PLANNING BOARD REPORT PORTLAND, MAINE

MMC Congress Street Hospital Building
22 Bramhall Street
Level III Site Plan
Project #000331-2018
53-D-7
Maine Medical Center, Applicant

Submitted to: Portland Planning Board Public Hearing Date: December 17, 2018	Prepared by: Nell Donaldson, Senior Planner Date: December 14, 2018
---	--

Figure 7: Proposed pick-up/drop-off circulation

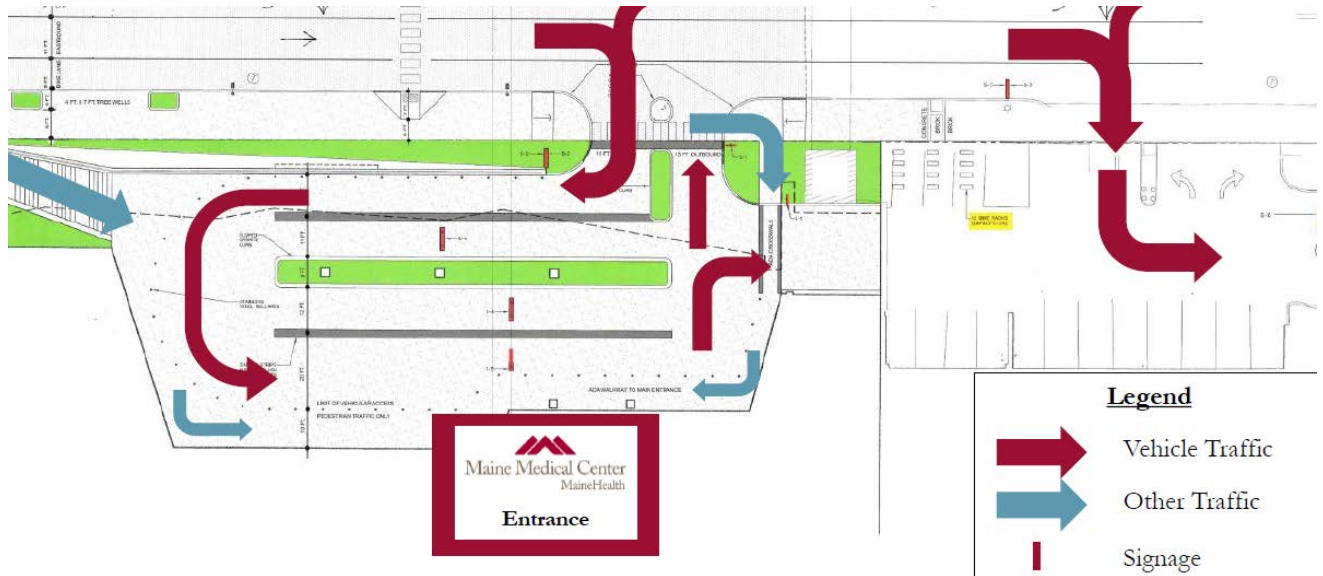
Revise striping plan to retain south side parking east of the Visitor's Garage entrance/exit to just west of Bramhall where the climbing lane will transition to Shared Lane Markings (centered in the travel lane). Show (north to south) an 8' parking lane, 11' travel lanes, a 6' climbing bicycle lane, and an 8' parking lane. This section should continue to Bramhall Street to the east. Please provide plans for restriping the entirety of Congress from Valley Street to Bramhall St/Deering Ave. The outside bike lane lines are to be dashed 6" lines for a minimum of 50' in advance of an intersection and through the intersection.

16' travel lanes are too wide for the WB approach to Valley Street. Retain existing westbound left turn pocket to Valley Street.
